Subject: Service Bulletin V2500-ENG-74-0009 dated February 27, 2020; IGNITION — PLUG, IGNITER — INTRODUCTION OF A NEW IGNITER PLUG TO INCREASE PART DURABILITY

IGNITION — PLUG, IGNITER — INTRODUCTION OF A NEW IGNITER PLUG
TO INCREASE PART DURABILITY

V2500-A1, V2522-A5, V2524-A5, V2527-A5, V2527E-A5, V2527M-A5, V2530-A5, V2533-A5

V2500-ENG-74-0009

LOCATION OF THE IGNITER PLUGS
74-21-41
FIGURE 1

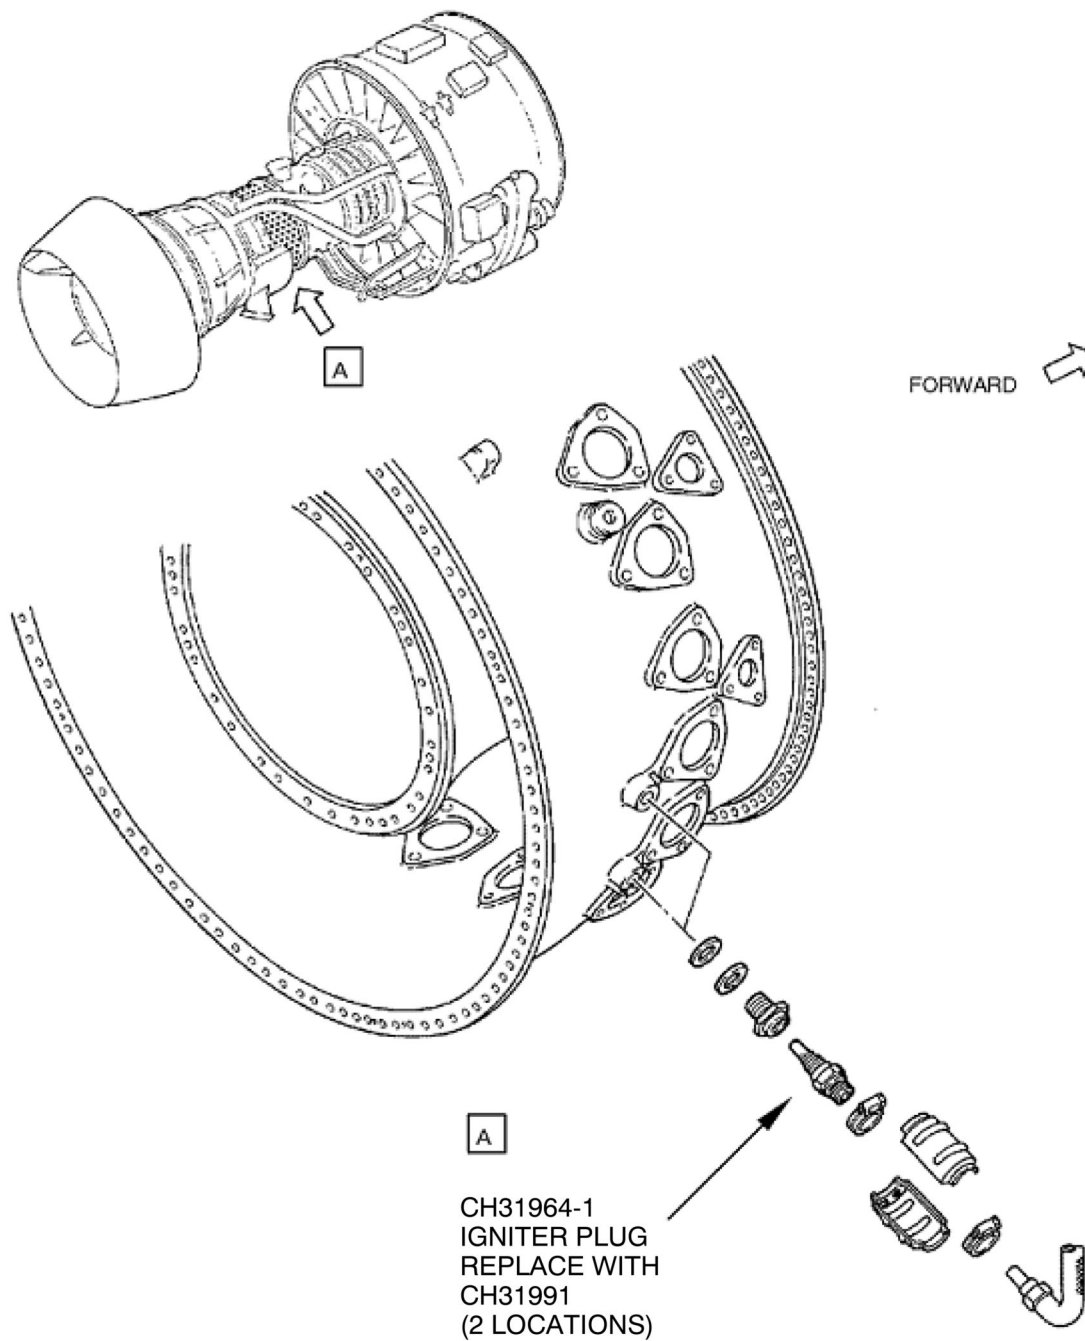
1. Replace the two Igniter Plugs, PN CH31964-1 with PN CH31991. See Figure 1.
2. Recording Instructions
 - A. A record of accomplishment is required.

IGNITER PLUG
FIGURE 2

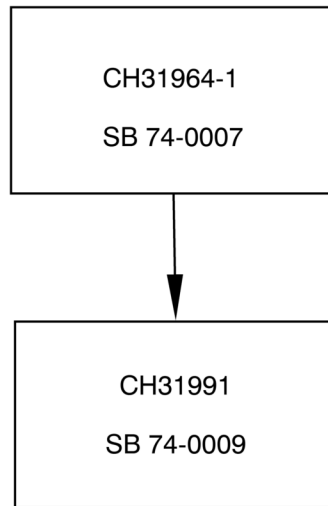
Parts Progression To Show the Changed Part in Relation to Other Parts
